Road Safety Audit Stage 1

Fontwell Avenue Bus Stop Works

Eastergate

Report Title Fontwell Avenue, Bus Stop Works, Road Safety Audit Stage 1

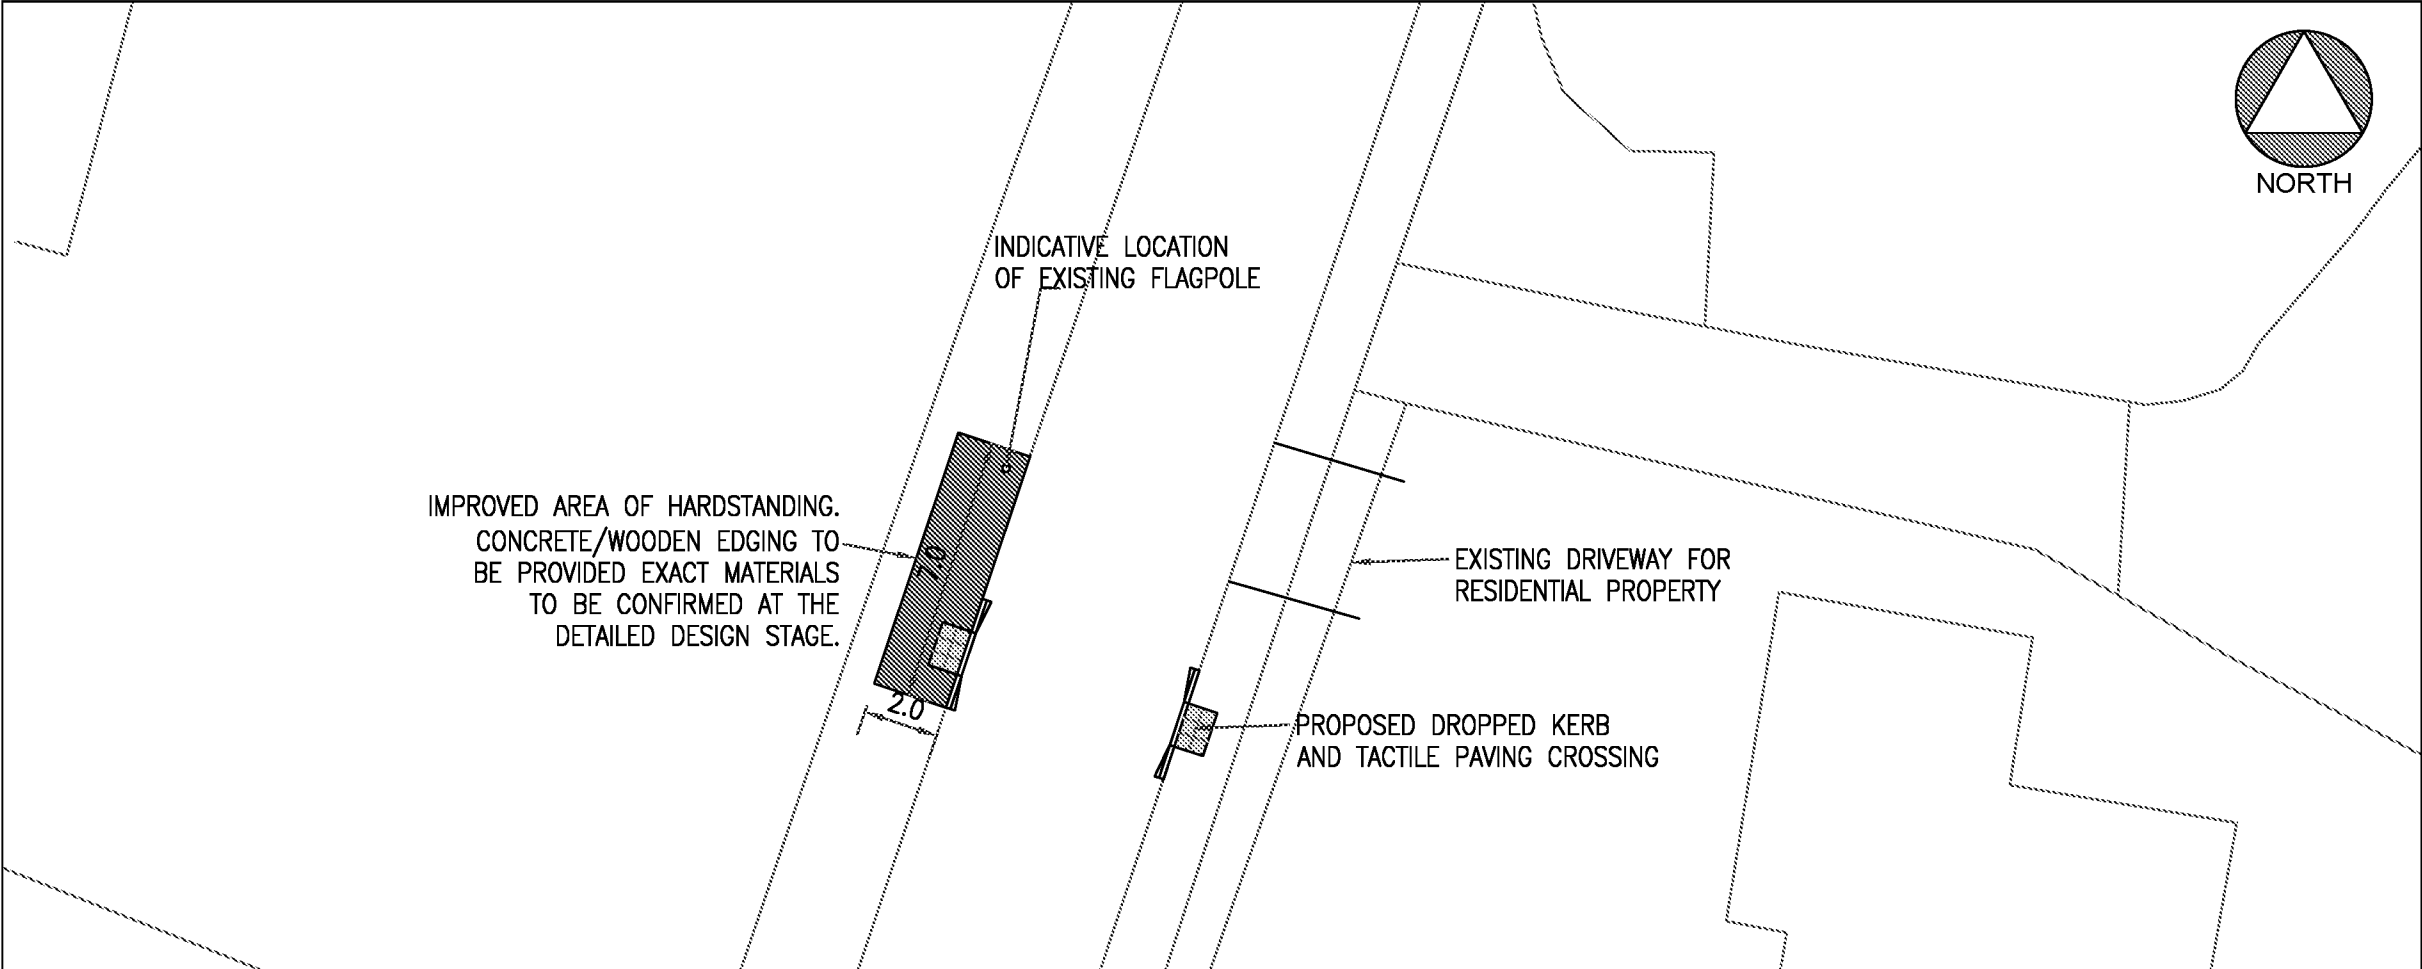
RSA Problem	RSA Recommendation	Design Organisation response)	Overseeing Organisation response	Agreed RSA action
3.4.1 Visibility splays have been shown at the crossing point, which are considered acceptable, however, in the southern visibility splay on the western side of the carriageway (at the bus stop position), the visibility splay is restricted by adjacent vegetation which could be worsened when the shrub is in leaf-see figure 1 in the report. Restricted visibility could lead to vehicle to pedestrian collisions, or sudden braking and rear end shunts.	It is recommended that the vegetation should be cut back and maintained.	The vegetation lies within the highway boundary and will therefore be maintained to ensure visibility.
